ALTERATION TO A HISTORIC PROPERTY STAFF REPORT

Site: 141 Central Street c.1889 William Veazie Row Houses
Case: HPC 2016.077 Single Building Local Historic District

Legal Notice: Alter/repair front porch (posts and corbels will be milled as-needed). Replace bottom step

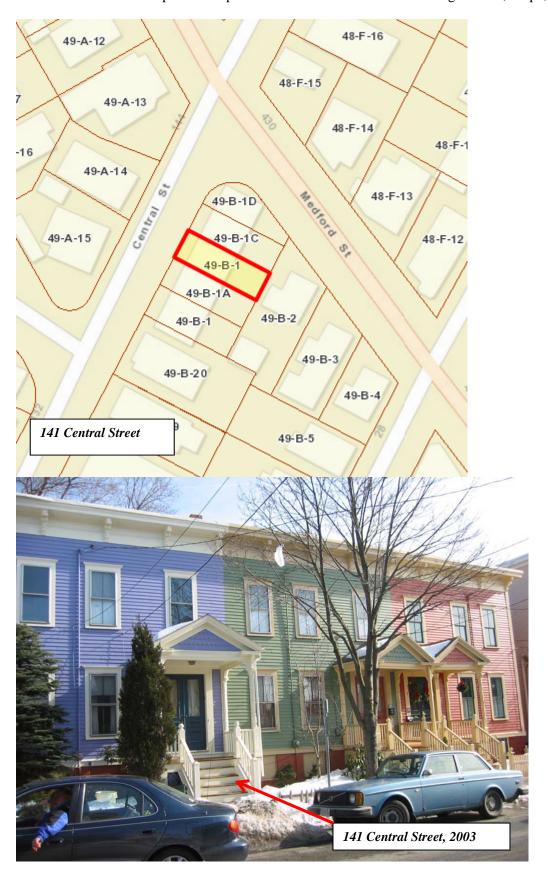
There have been a no instances where a single bottom step has been replaced by stone or concrete. It should be noted that all the other entries in the rowhouse have a concrete bottom step.

141 Central Street has a full set of wood steps. The porch and steps need to be repaired and are in fair to poor condition. The bottom riser is rotting. The other rowhouses have a concrete bottom step.

The stairs, porch and handrails visible from the public right of way were not discussed in the Form B. The deteriorated steps would be replaced to match the others in the row. Porch columns and other damaged and rotting details would be replicated to match the existing.

- 1. All appropriate building permits shall be obtained prior to the start of any work.
- 2. If changes are necessary to the proposed design for which this Certificate of Appropriateness was issued, new plans shall be submitted to Historic Staff prior to commencing the work.
- 3. The bottom step shall be replaced with either granite or concrete to match the other bottom steps in the row
- 4. Historic Staff shall issue a sign-off upon completion of the project that it was executed in accordance with this Certificate and approved plans.

1. The wood replacement porch columns shall match the existing in form, shape, and size.
